**ADDENDUM NO. 3  
TO  
CONTRACT DOCUMENTS**

**PIN 8761.66: REPLACEMENT OF THE HILL BOULEVARD BRIDGE  
OVER BARGER BROOK TRIBUTARY**

**PIN 8761.71: REPLACEMENT OF THE VETERANS ROAD  
CULVERT OVER HALLOCKS MILL BROOK**

**May 12, 2020**

WATERMAIN DETAILS 2 OF 3  
DRAWING NO. WMD-2  
SHEET NO. 54A1

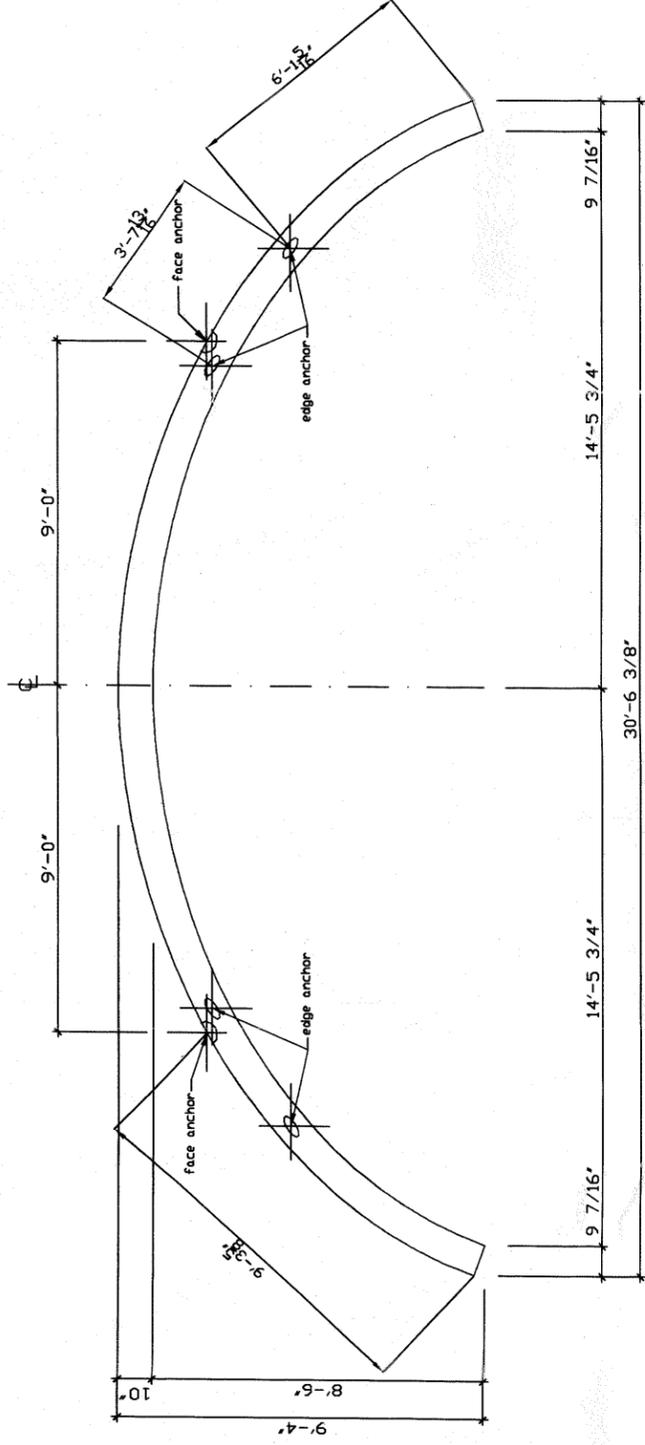
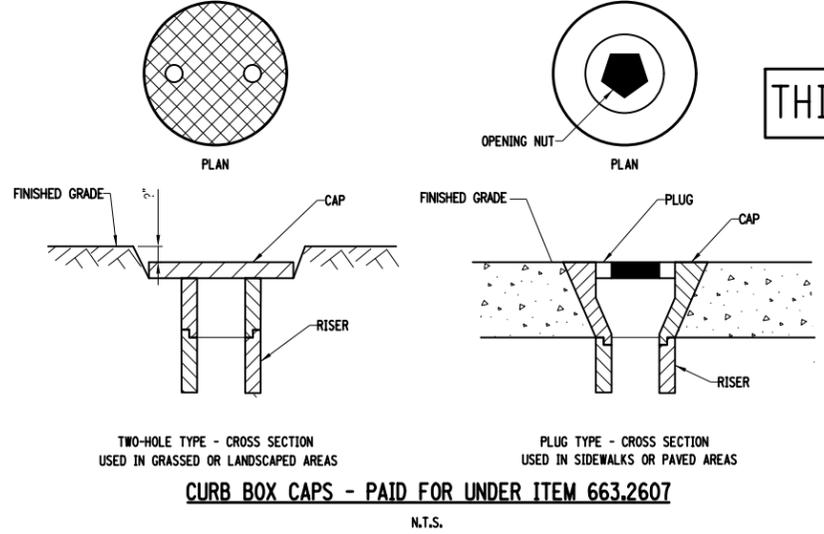
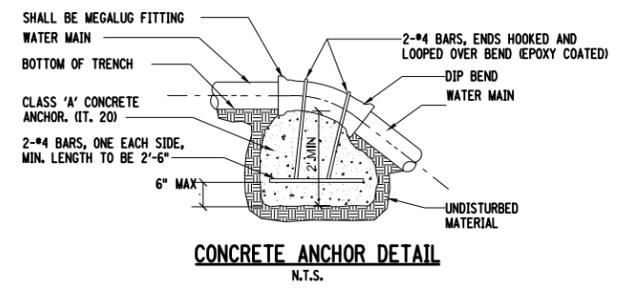
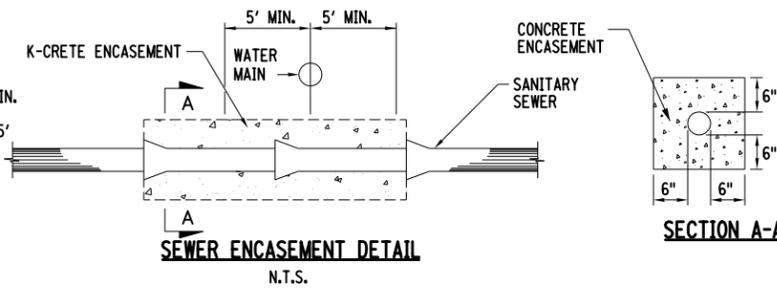
Q14:	<p>On drawing WMD-1 (sheet 53), referring to tables for the various thrust restraint / thrust block dimensions.</p> <p>14a.) Note 9 refers to the standard conditions used to determine the thrust block dimensioning. Please confirm bidders should use the same standard conditions to calculate the required thrust block dimensions (i.e. safety factor of 1.5, depth of cover of 5'-0", water system test pressure of 200 psi, soil bearing capacity of 14 psi, and soil unit weight of 90 lb/cf). If not, please indicate what conditions bidder should use to calculate the thrust block dimensions.</p> <p>14b.) The table for minimum restrained length of pipe (ft-in) L<sub>r</sub>, does not include 12 NPS. Please indicate the minimum restrained length of pipe for both horizontal and vertical thrust restraint details.</p> <p>14c.) On drawing WMD-2 (sheet 54), referring to concrete anchor detail. Note 2 refers to excavation, placing of concrete, and other incidental expenses to construct concrete anchors (vertical bend thrust blocks) to be included in the unit price bid for concrete masonry (class b). Measurement and payment under this item shall be limited to those dimensions as shown on the detail. Bidder cannot locate the</p>

length or width of concrete anchor in detail to develop quantities. Bidder cannot locate indicated bid item. Please indicate dimensions and bid item to carry all costs for thrust blocks.
A14:	<p>14a) The contractor shall use the thrust block dimensions as provided in the thrust block dimension tables on dwg. No. WMD-1, if field conditions differ any changes will be addressed in the field with approval of the engineer.</p> <p>14b) Please see NYS DOT standard sheets 663-02 and 663-03.</p> <p>14c) Payment for all thrust blocks shall be included as part of the bid price for the water main, fittings and appurtenances, as per the basis of payment section of the NYSDOT Standard Specifications (General 663-5.01). The contractor shall utilize the dimensions on standard sheet 663-03 to develop pricing.</p>
Q15:	Are there liquidated damages on this project?
A15:	Liquidated Damages are as described within the sections "Completion Date" and "Failure to Complete Work on Time", Sections 108-2 and 108-03 of the NYSDOT Standard Specifications, respectively. Based on the anticipated construction value of this project, liquidated damages are expected to be \$2,000 per calendar day.
